**RE: Multi-Use Recreational Facility
Grading and Drainage Plan
Stamp Date: 10/30/17
Hydrology File: F16D003E1**

Based upon the information provided in your submittal received 11/07/2017, the Grading and Drainage Plan **is not** approved for Building Permit. The following comments need to be addressed for approval of the above referenced project:

ATTACHMENT #1

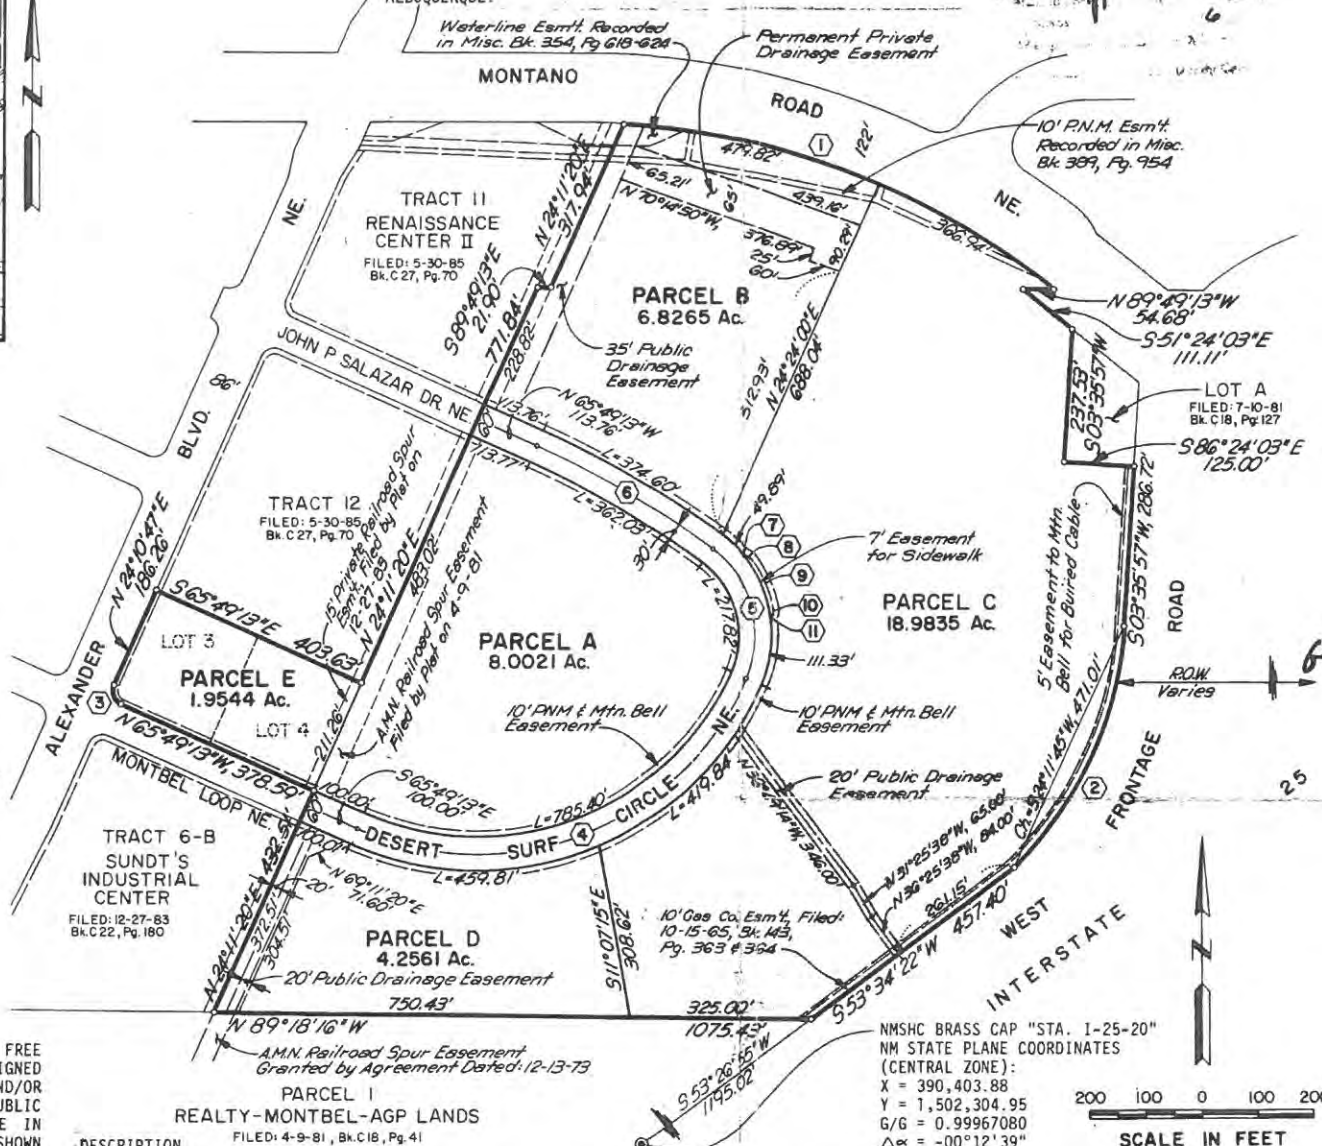
20. Sheet C4. Please add all Drainage Easements per recorded plat. See attachment #1. Also show recording information on Grading Plan.
21. Sheet C4. Please provide all Street Capacity calculations to show that the existing streets can handle the additional proposed runoff.

ATTACHMENT #2

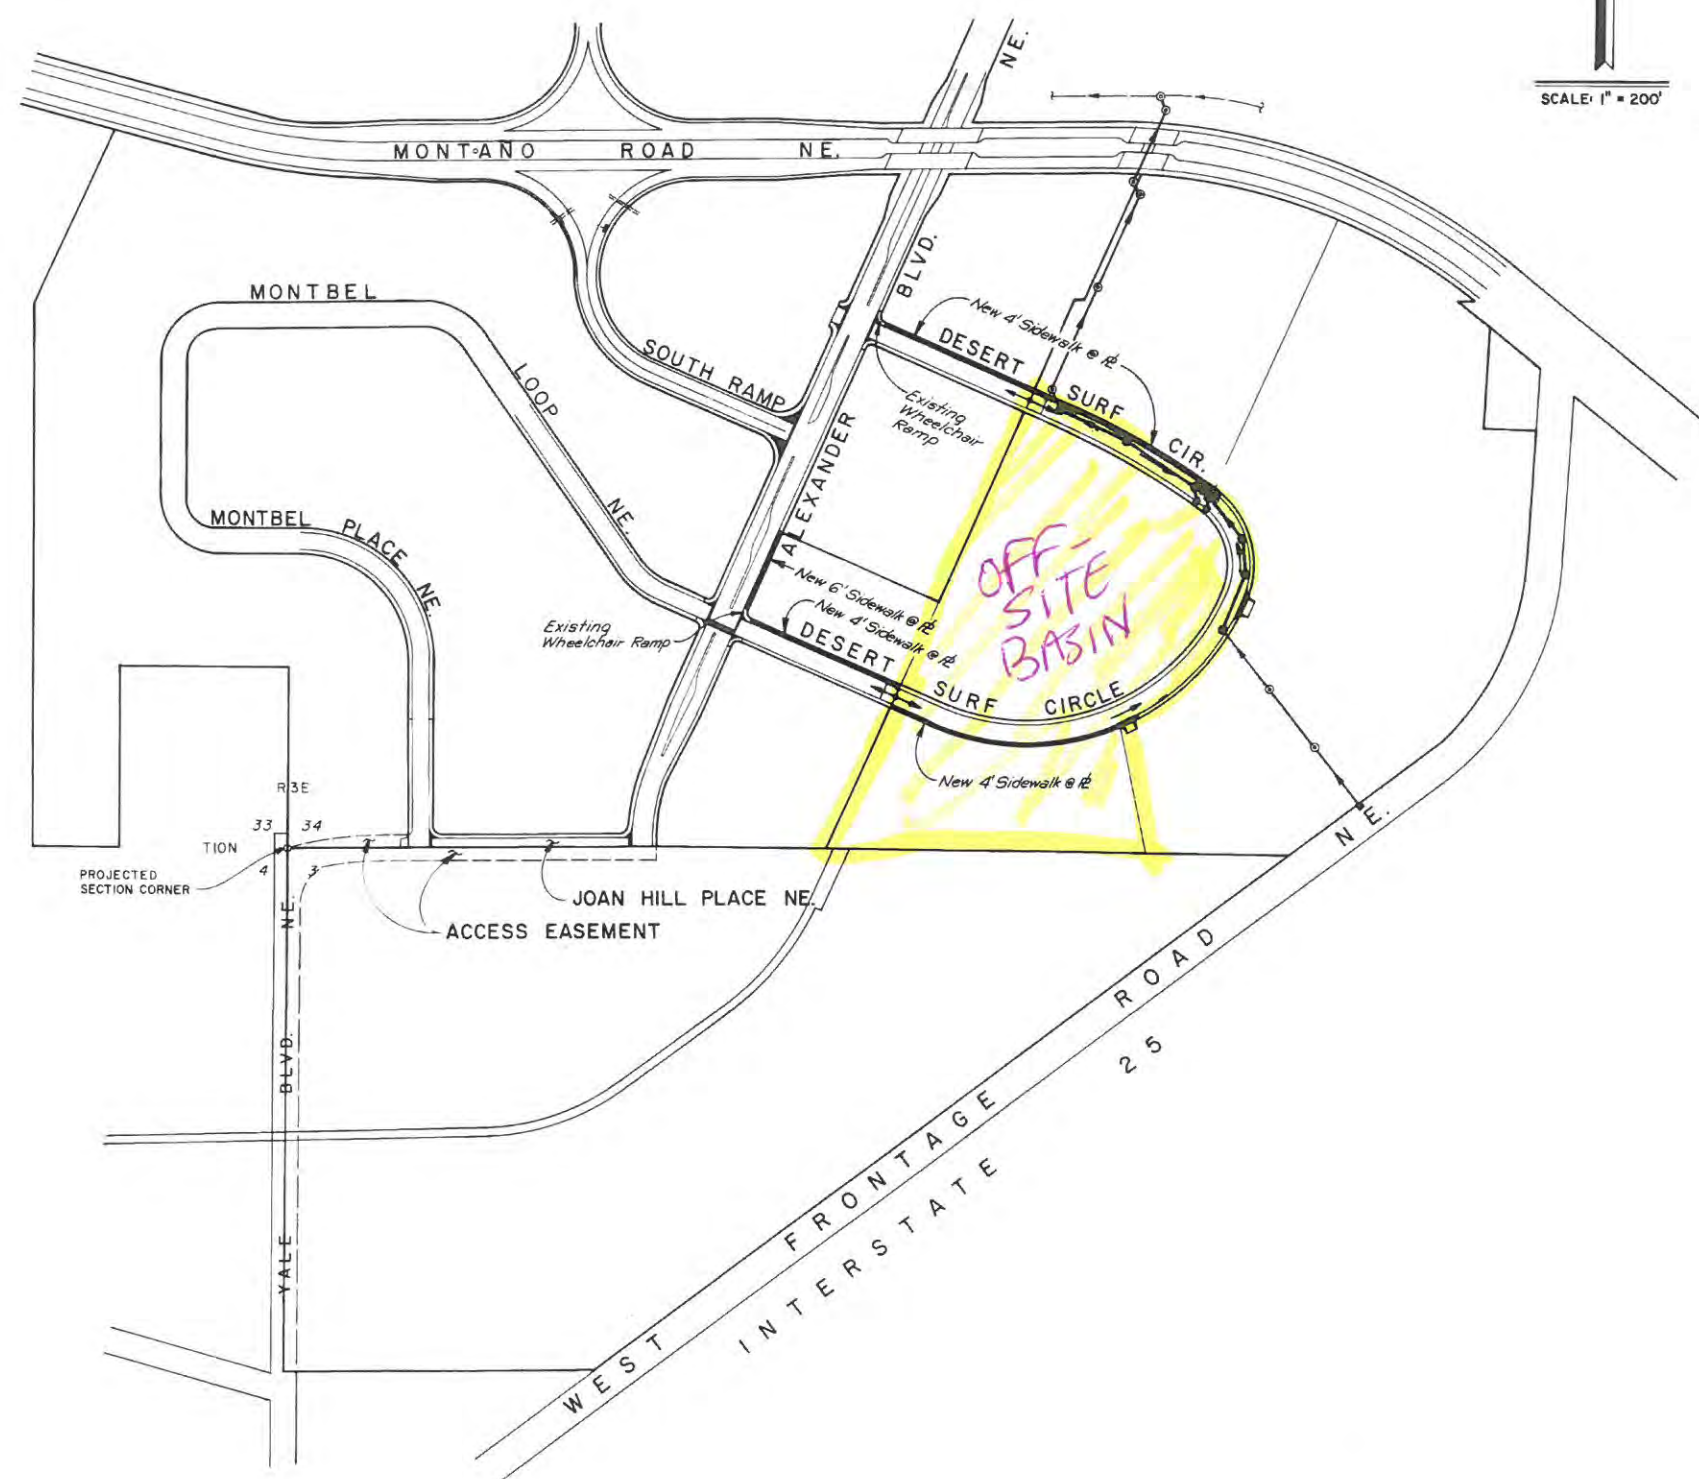
18. Sheet C4. Please show all calculations for the Off-site Basins or where the runoff calculations were obtained. See attachment #2.
19. Sheet C4. Please show all off-site basins that contribute to the existing storm sewer on Desert Surf Circle that is going into the proposed Retention Pond.

DRAWN BY
JUG
DATE
10-30-17
2017035 GRADING PLAN
SHEET #
C3
JOB #
2017035

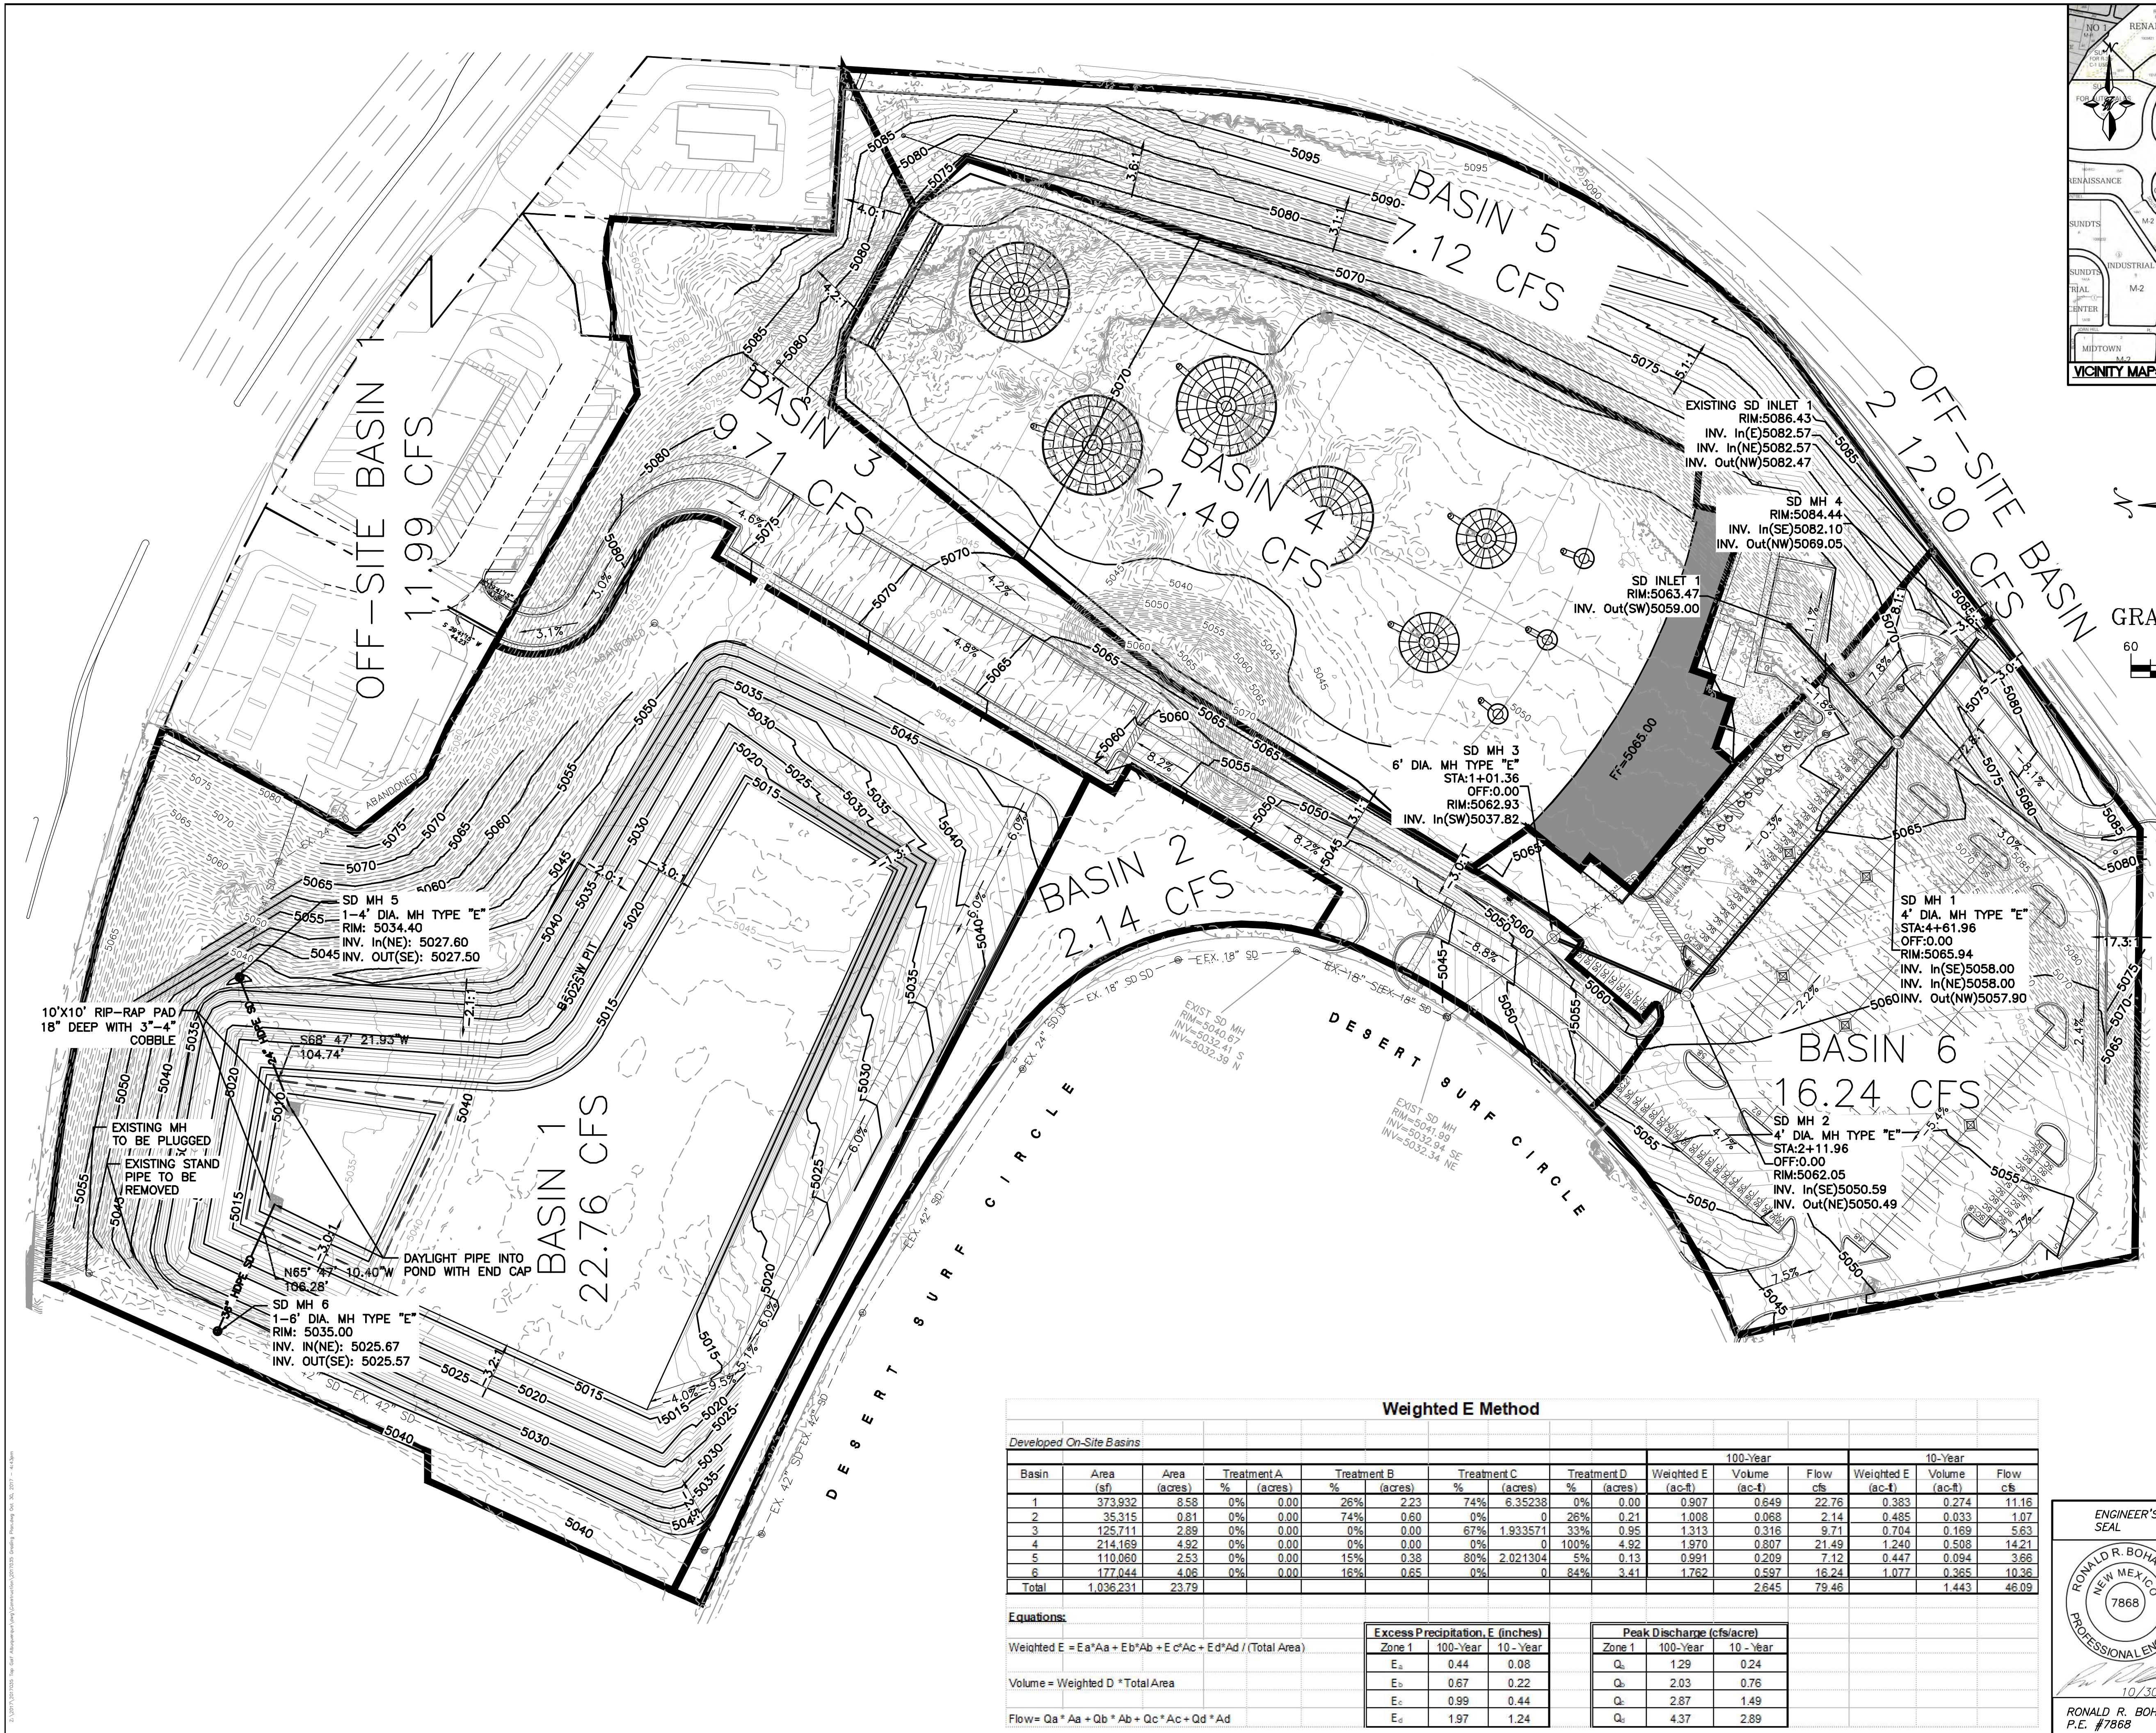
1. Sheet C3. Please provide the flood plain effective date to the FIRM information.
2. Sheet C3 & C4. Please label both streets "Montano Rd" and "Interstate 25".
3. Sheet C3 & C5. Please provide a cross section from the Pickle Ball Courts through Desert Surf Circle.
4. Sheet C3 & C5. Please provide a cross section from the southeast Youth Field through the parking area uphill.
5. Sheet C3. There are missing grades near Desert Surf Circle by the Youth Field. Please add them.
6. Sheet C3. The proposed grades in the area of the southeast Youth Field and the parking area uphill need to tie back into the existing grades. Please fix them.
7. Sheet C3. In general I noticed that some of the proposed grades need to tie back into the existing grades. Please fix them.

8. Sheet C3. In general, there are a lot of grading being done and this sheet is very busy. Please rescale the Grading Plan to have a maximum scale of 1"=40' or 1"=30' so that it is readable.

9. Sheet C3 & C4. Some of your grade arrows are pointing up gradient. Please correct.
10. Sheet C3. Under the Proposed Drainage Management Plan, it states that it will continue using the existing drainage system designed for the original Beach Waterpark development with some modifications. What drainage system is this referring to and what modifications?

11. Sheet C3. Under the Proposed Drainage Management Plan, Please add the words "approved Drainage Report dated 9/15/15 by Tierra West."
12. Sheet C3. Under the Proposed Drainage Management Plan, it talks about the proposed detention pond. This is in fact a proposed retention pond. Please change the wording.

13. Sheet C3 & C4. Under the Proposed Drainage Management Plan, it states that the off-site drainage from I-25 will now be directed back to the proposed detention pond. Please label the portion of the existing storm sewer after the proposed manhole as "abandoned in place".

14. Sheet C3. Under the Proposed Drainage Management Plan, Basin 4 talks about into a series of drop inlets and conveyed to the detention pond. Please show this proposed storm sewer system on Sheet C4.

15. Sheet C3. Please add a note as how all disturbed areas are to be revegetated.
16. Sheet C4. Under the Weighted E Method for Basin 1. Please verify that the Youth Fields will produce a 26% Treatment B. This may be more.

31. Sheet C4. Please provide the detail of the outfall structure into the detention pond from the existing McDonald's site.
32. Sheet C3 & C4. Please provide a private drainage easement centered along the both the existing storm sewer from the existing McDonald's site and the proposed storm sewer entering the proposed pond. This easement should be stated on the Grading Plan as to be for the benefit of the McDonald's site (please label the legal description of the property) with the recording information of the private easement.

33. Sheet C3 & C4. Please provide a public drainage easement around the proposed retention pond. Please include the recording information for the Public Drainage Easement on the Grading Plan.

34. Sheet C3 & C4. An Agreement and Covenant for the Public Drainage Easement for the proposed retention pond will have to be recorded prior to Hydrology's approval for Building Permit. Please include the recording information for the Agreement and Covenant on the Grading Plan.
